INTERDEPARTMENTAL REVIEW COMMITTEE

Meeting Minutes
Thursday, August 1, 2024
10 AM

MEMORANDUM

DATE: August 21, 2024
TO: Desirae Lujan – Senior Planner
THROUGH: Juan Rael, P.E. – Public Works Director *JR*
FROM: Eric Ulibarri, P.E., C.F.M. – County Engineer *EU*
CC: Paul Andrus, Community Development Director
RE: Sherwood Rounds_114-120 Longview Drive
Final Plat Application Public Works/Engineering Comments and Conditions

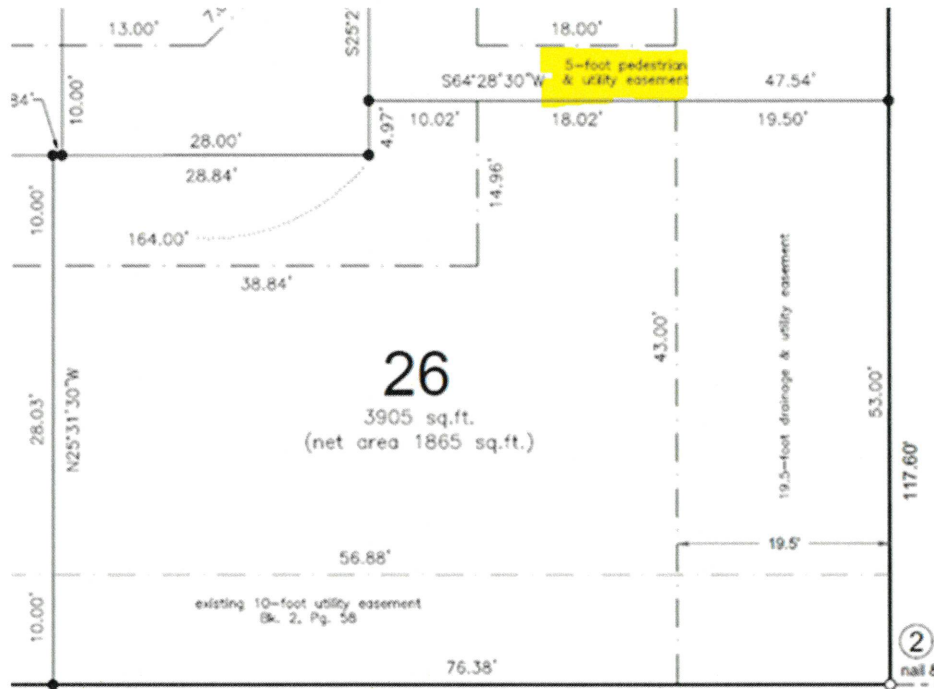
- **Subdivision Plat:**
 - These items shall be addressed prior to approval of the final subdivision plat.
 - Sheet 1 of 4:
 - Utility Easements: A 10-foot maintenance vehicular access road (ingress/egress) and drainage easement shall be granted to the County for vehicular access to SE pond from within interior streets between Lot 25 and 26. This easement will need to be shown clearly on all sheets in the plat document. See image below.

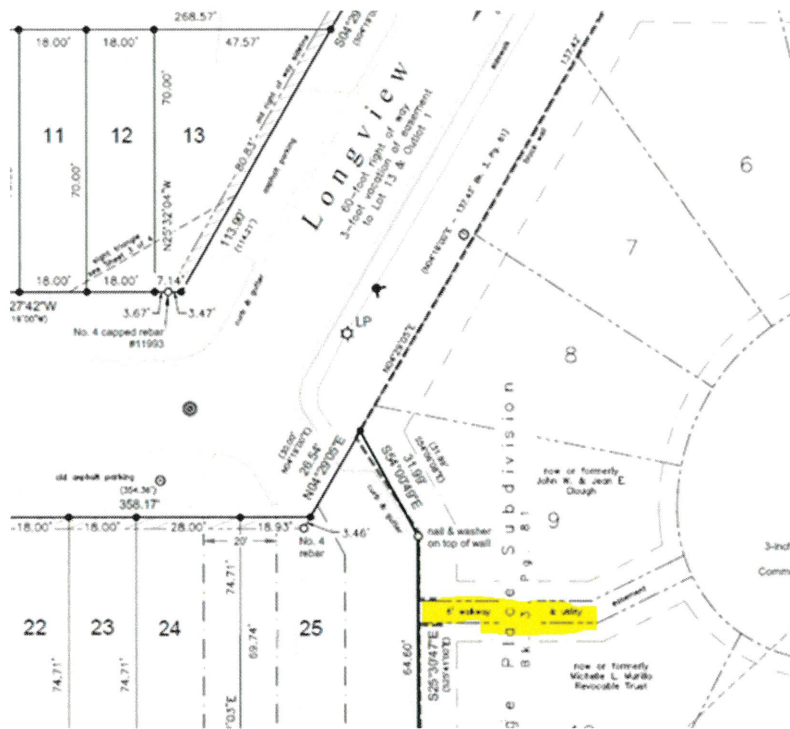
- Sheet 2 of 4:
 - Label the easement for the SE pond area.
- Pedestrian access and Easement:
 - Provisions shall be included in the final design to allow construction of additional pedestrian infrastructure allowing access from the property to the east into the

proposed Sherwood Rounds development and access to Longview Drive. Easements shall be included in the Final Plat as necessary to allow this pedestrian access. See image below.
